Cory Decarbonisation Project

Responses to Deadline 1 and Deadline 2 submissions on behalf of Landsul Limited and Munster Joinery (U.K.) Limited

ANNEX A

Figure 1 – Contextual Indicative Equipment Layout

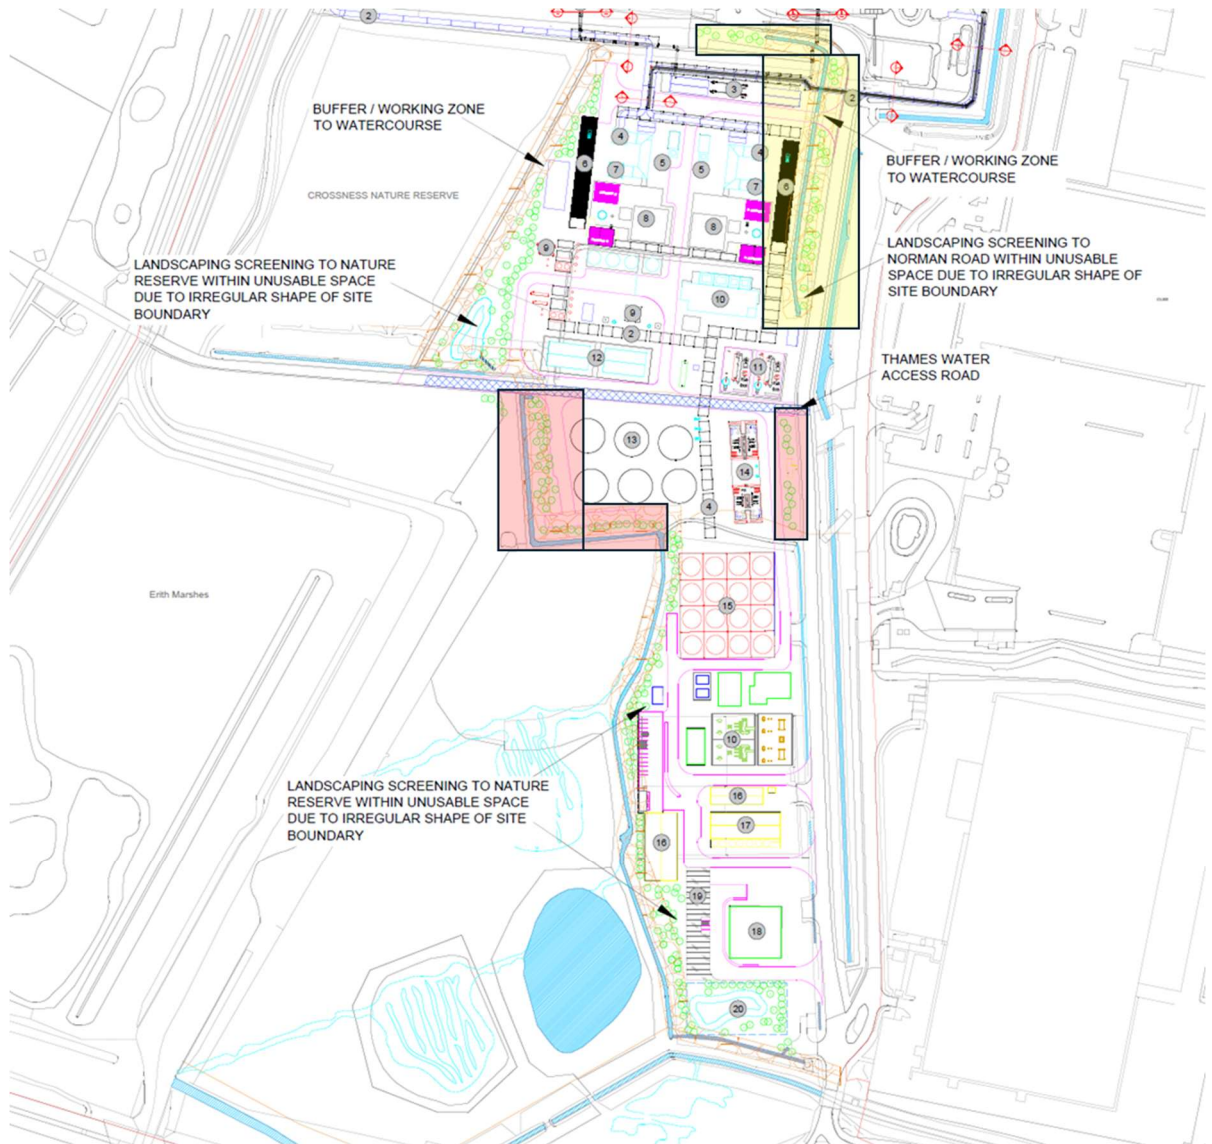
- 4.2 In Figure 1, I have highlighted (yellow and red boxes) a number of areas of planting. As can be seen from the Applicant’s text on the figure, it is contended by the Applicant that (at least for the yellow areas) this is “unusable space due to the irregular shape of site boundary”. I do not agree that this space is irregular – it is actually quite rectangular and would be entirely useable as part of the operational area. It is less clear whether the Applicant also makes this contention for the areas highlighted in the red boxes but, again, I would not consider these spaces either irregular or unusable.

- 4.3 For context, my estimate is that the planting shown in the yellow and red boxes has a footprint of approximately 7,000 m².
- 4.4 It is also important to note that in terms of the planting to west of the northern part of the site, my Alternative Layout would enable very similar planting / screening to what the Applicant proposes. For the planting to the west of the southern part of the site (which is a genuinely irregular shaped boundary) the Alternative Layout again is similar to the Applicant’s scheme and would thus enable similar planting / screening to what the

Applicant proposes. Finally, the smaller footprint of the Alternative Layout clearly can reduce the visual impacts of the development and enable significantly more planting should that be required. For instance, the entire area south of the Munster Joinery land could be planted if so desired in the Alternative Layout.

Figure 2 – Projected Heat Demand

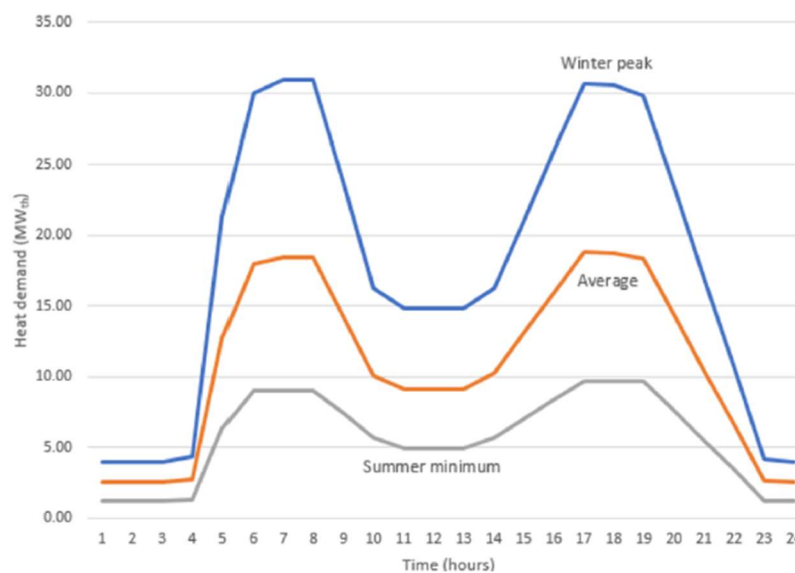
4.7 The shape of the heat profile is typical but does indicate the challenge in developing this sort of infrastructure as there is significant variation both on seasonal and daily basis. This means that whilst a significant capacity (and hence capital cost) is required to meet peak winter demand the relatively lower annual demand means that it can be challenging to recover this capital investment through heat sales. This is noted by Fichtner in section 2.4 of the report where it is stated that “the net present value (before financing and tax) over 33 years is negative”. However, in May 2021 Cory was awarded a £12.1 million grant through the Government’s Heat Network Investment Project (HNIP) to help improve the economic feasibility of the scheme.

Figure 3 – Heat load duration curve

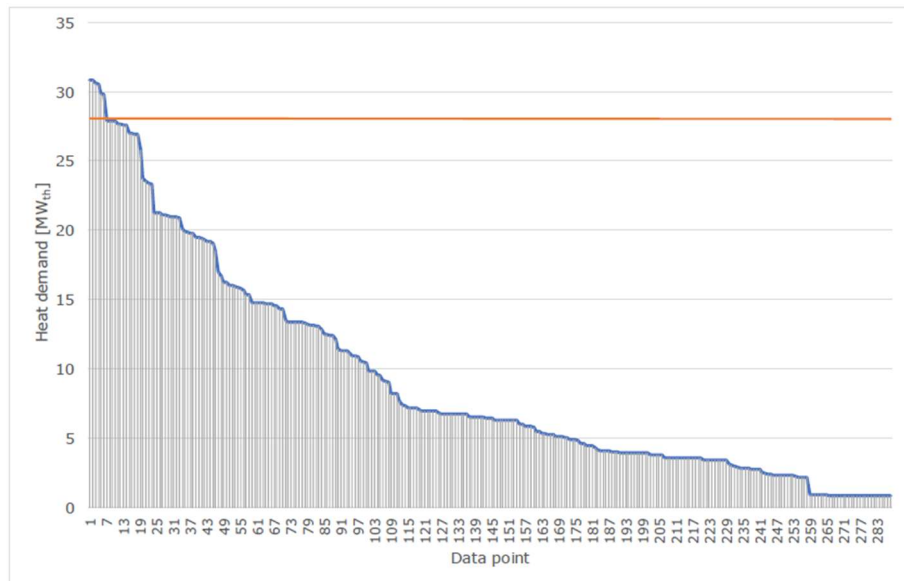
- 4.9 It can be seen that, for the vast majority of the time, the heat that can be exported by Riverside 1 is significantly higher than the demand.
- 4.10 The Applicant suggests that the carbon capture plant will provide 100 MWt^[5] of heat. However, in the context of the report that Cory themselves commissioned, it would appear that there is no identified demand for this heat.

Figure 4 – Applicant's Electrical Distribution Philosophy

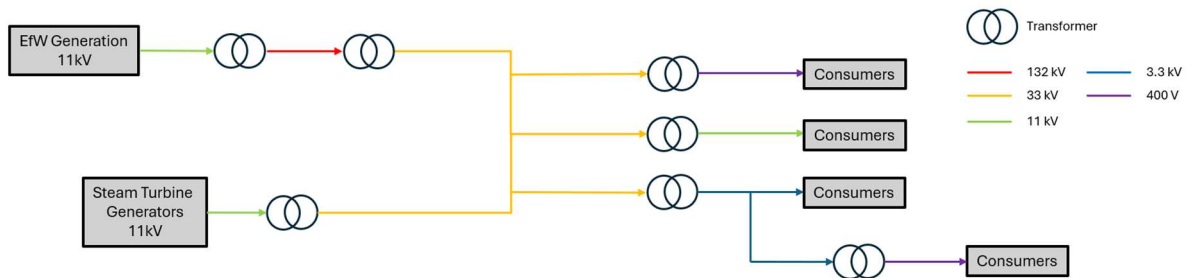
4.24 The design of any electrical distribution system requires the designer to select the most appropriate voltage for distribution. In general, the higher the voltage, the larger and more costly the equipment. However, larger loads require higher voltages and higher voltages also result in lower distribution losses which reduces operating costs. Balancing that however are transformation losses whereby every time the voltage is stepped-up or stepped-down (changed to a lower or higher voltage) losses occur.

4.26 As I have highlighted in my initial report (paragraphs 2.19 to 2.21) the Applicant has included space allowance for a large switchyard as part of the indicative equipment layout. The reason for this switchyard is driven by the electrical distribution philosophy as the use of multiple voltages (in particular the 132kV and 33kV systems) requires significant electrical plant.

- 4.29 It should be recalled that the total electrical load for the carbon capture facility has been confirmed by the Applicant to be 42MWe^[12]. It is clear from Figure 5 above that for a load of this size, 132kV is a very high voltage. In reality, electricity would be supplied by both Riverside 1 and Riverside 2 so each of the two 132kV lines would only be supplying 21MWe peak but for the vast majority of the time, the actual voltage supplied would be zero (assuming the primary generation from the back-pressure steam turbines is sufficient) or less than 5MWe if a small amount of top-up power was required.

- 4.30 It follows that, in my opinion, there is no requirement to distribute electricity from the Riverside 1 and Riverside 2 plants at as high a voltage as 132kV.

Figure 6 - Southern Extent of Applicant's Layout

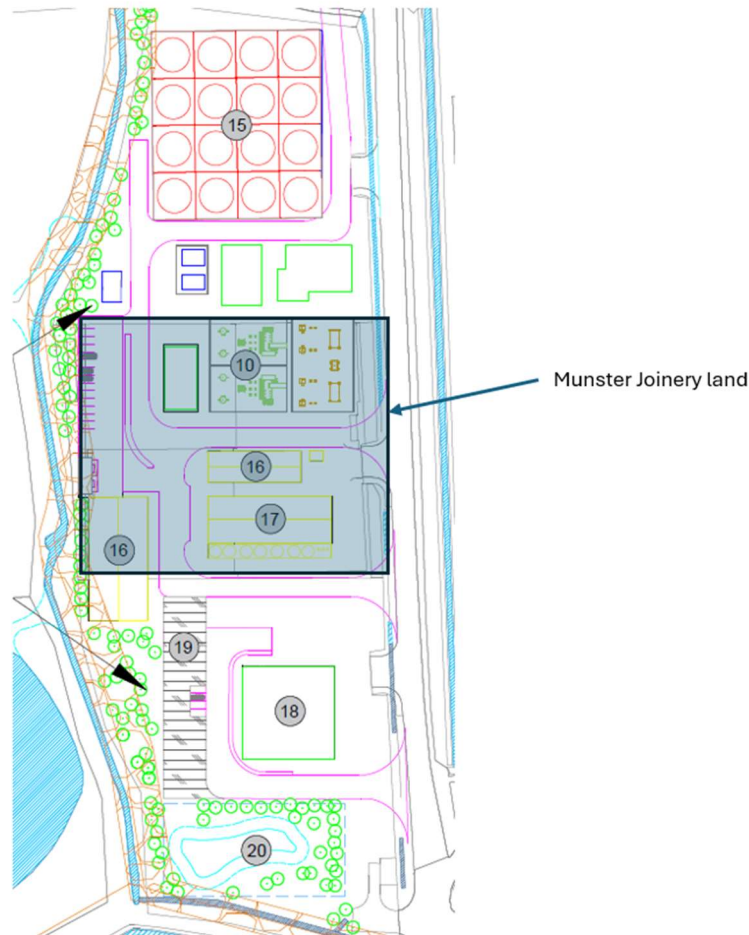
4.41 The table below shows the plant and equipment that, in the Applicant's layout, is accommodated either on the Munster Joinery Land or south of it this along with the required footprint for that equipment.

- 4.43 It is important to note that, because the water storage tank is underground, it would be possible to locate plant or buildings above this provided that suitable manhole access is maintained for maintenance. For instance, in my layout I have included operational laydown above. In contrast, the Applicant has put landscaping / planting above the water tank.

- 4.44 It can be seen from Figure 6 that in terms of the use of the Munster Joinery Land and areas to the south, the Applicant only uses a relatively small amount of this for process equipment. Indeed, of the approximately 19,000 m² of land, the Applicant has used approximately 5,000 m² for planting. There is then 9,000 m² of above ground equipment (counting only the half of the switchyard that is in this area) with the remainder being roads, car parking and additional space.

Figure 7- Key Drivers for Footprint Reduction

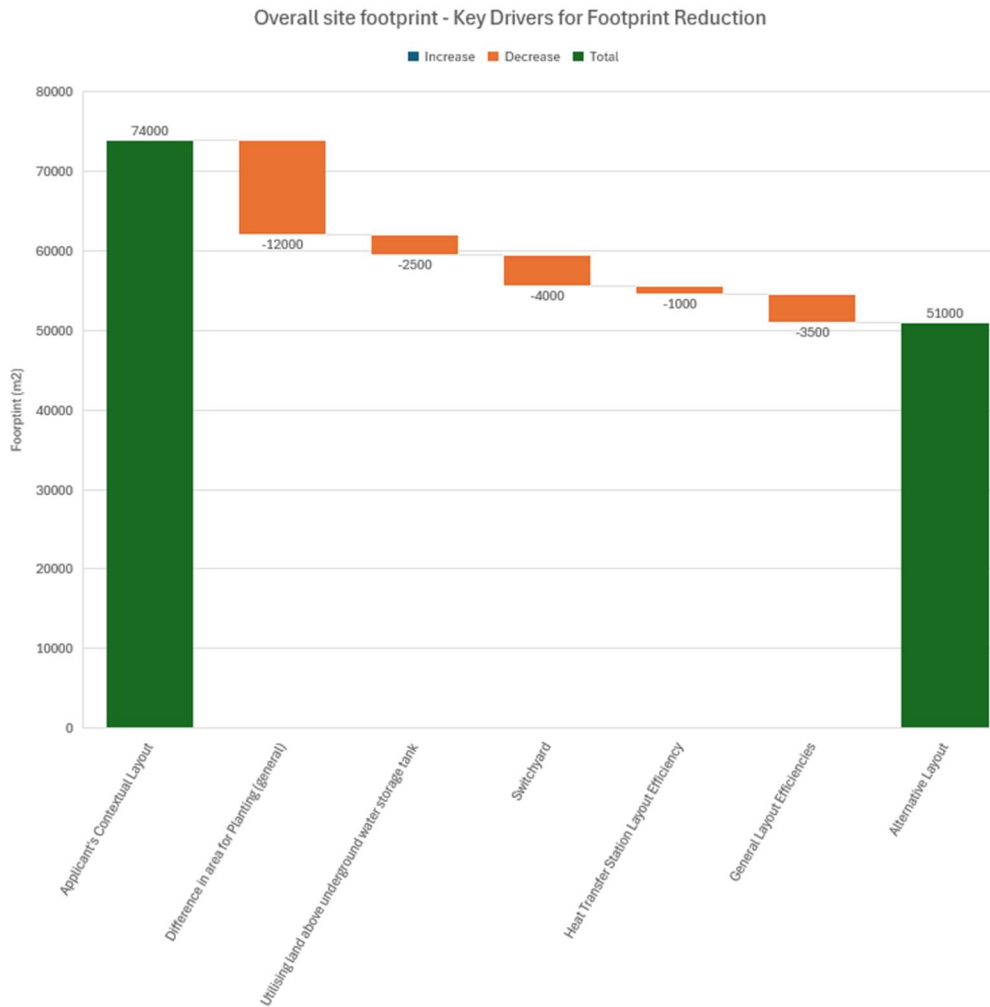
- 5.6 In Figure 7 below, I present a waterfall chart that shows the key drivers in the footprint reduction between the Applicant's Contextual Layout and the Alternative Layout that I have prepared.

- 5.7 In addition to the above, further reductions in footprint could be achieved by:
- (a) Moving to a single line plant rather than two line (saving estimated at 2,500 m² – see section 4.6 of my Initial Report)
 - (b) Removal of the Heat Transfer Station (saving approximately 4,000 m² in terms of total land required based on my revised Alternative Layout)
